ADDENDUM NO. 1 July 17, 2020 223279

#### RE: TOWN OF ADDISON, VERMONT ADDISON COMMUNITY WASTEWATER SYSTEM

FROM: DuBOIS & KING, INC. P.O. Box 339 Randolph, Vermont 05060 (802) 728-3376

# **ATTACHMENT 3**

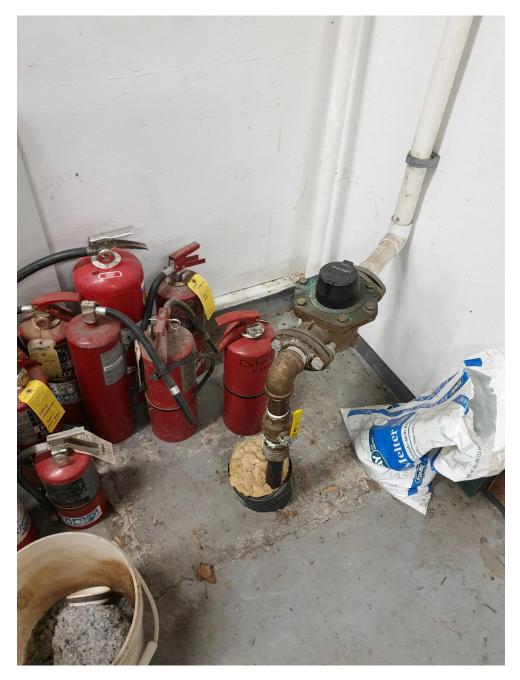
Existing meter location on domestic line in Fire Station. Proposed location for new meter.

Existing meter location on line to fill trucks in Fire Station. Proposed location for new meter.
